## SAF Axle/Suspension

### SAF Axles with PSI Tire Inflation to Now Have ThermALERT™ Option as Standard

Effective February 2018

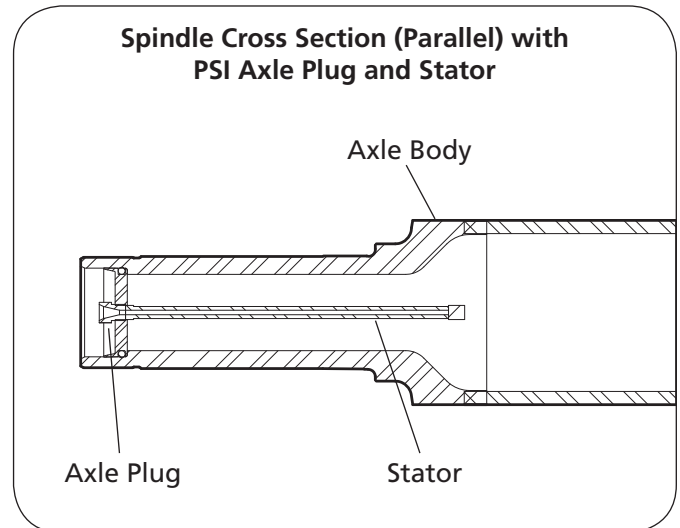
All SAF axles and suspension systems equipped with PSI tire inflation will now have the ThermALERT™ feature as a standard offering. The prior design axle plug without ThermALERT™ will no longer be available.

The ThermALERT™ feature will indicate a possible thermal related wheel end event as the insert will melt at a predetermined temperature and create an audible whistling noise.

- Axle part numbers with PSI prep that DO NOT already include ThermALERT™ will become obsolete.
- ThermALERT™ plugs can be used in place of standard PSI plugs for service repairs.
